REGULATORY INFORMATION DISTRIBUTION SYSTEM (RIDS)

SUBJECT: Forwards rev to Section 8 of Cycle 3 reload analysis rept.

Subject: Palo Verde Nuclear Generating Station (PVNGS)
Unit 1
Revision to Section 8 of Reload Analysis
Report for Unit 1, Cycle 3
File: 89-E-056-026

SUBJECT: SUMMARY OF MEETING WITH THE COMBUSTION ENGINEERING OWNERS
GROUP (CEOG) REGARDING THE DEFAS DESIGN FEATURES TO BE
INSTALLED PER 10 CFR 50.62 (THE ATWS RULE)

**3410 MWt PLANT CLASS
LOFW ATWS
PEAK PRESSURE VERSUS MODERATOR TEMPERATURE COEFFICIENT**

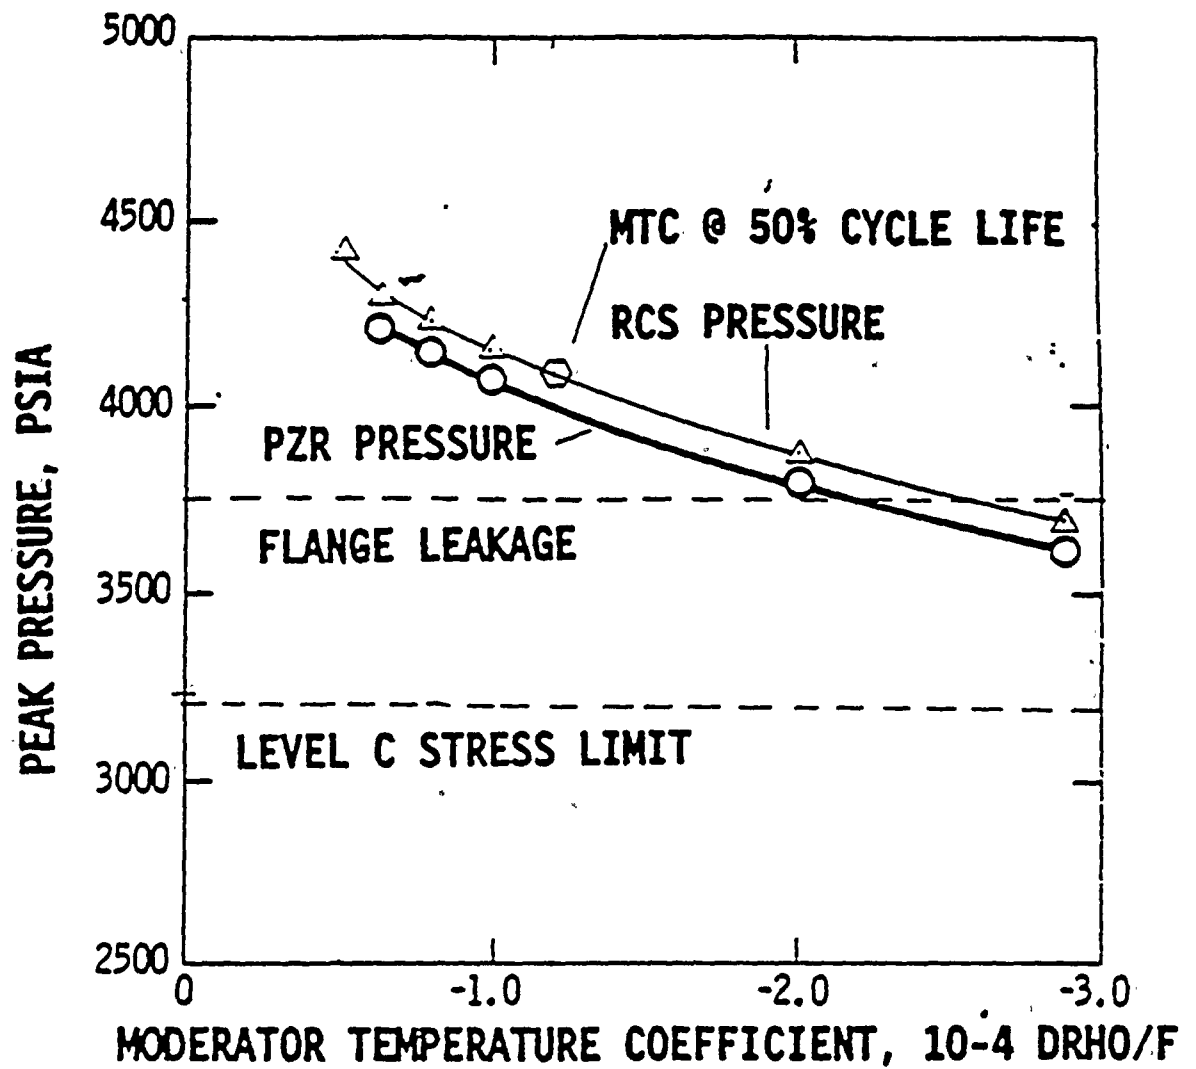
PROVIDE A DISCUSSION OF SGLL AS AN ALTERNATIVE TO THE DSS INTERLOCK

WILL EARLIER AUX. FEED ACTUATION MITIGATE AN ATWS EVENT FOR LATER TIMES IN THE CYCLE

FOR LIMITING ATWS SCENARIO, AUX. FEED TIMING HAS LITTLE IMPACT ON PEAK PRESSURE

FOR THE 3410 MWT CLASS THERE IS NO TIME IN THE CYCLE WHICH YIELDS ATWS PEAK PRESSURES BELOW LEVEL C STRESS LIMITS (CENPD-263)
